Subject: Tansmittal of Revision 2 to Service Bulletin Number

V2500-NAC-78-0099

NACELLE - EXHAUST - ACTUATORS AND MANIFOLDS, THRUST REVERSER DOOR OPENING - REPLACEMENT OF

- (1) Aircraft: MD90
- (2) Nacelle: V2500-D5 Thrust Reverser serial numbers 0021001 through 0040001.

HYDRAULIC MANIFOLD BRACKET REWORK. FIGURE 1

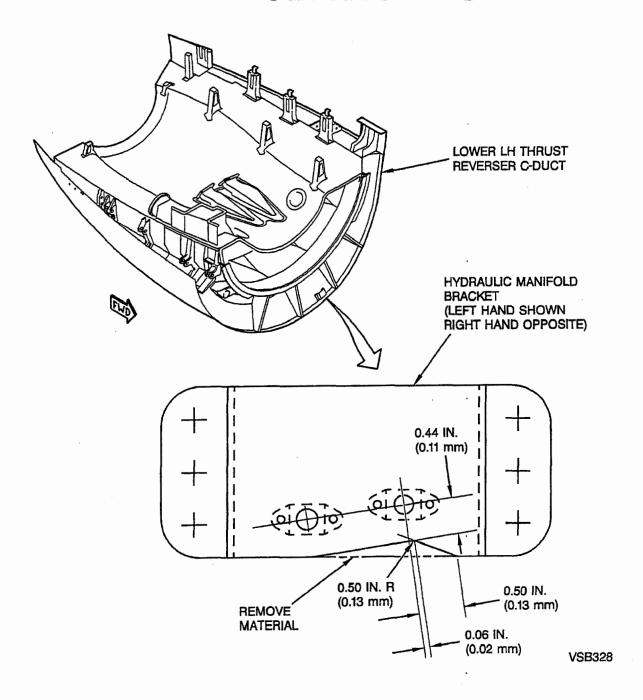
- Install the 1211443-001 and 1211444-001 replacement upper and lower thrust reverser opening actuators. Refer to the Aircraft Maintenance Manual, Chapter 78-35-11.
- Remove two B55818-2 hydraulic manifolds. Refer to the Aircraft Maintenance Manual, Chapter 78-35-12.
- Remove indicated material from hydraulic manifold brackets. See Figure 1.
- Clean the rework surface. Refer to the Standard (5) Practices/Processes Manual, Chapter 70-11-03.

NOTE: MS21902J4 unions and MS28778-4 O-rings installed on existing actuators and manifolds are not used with new actuators and manifolds.
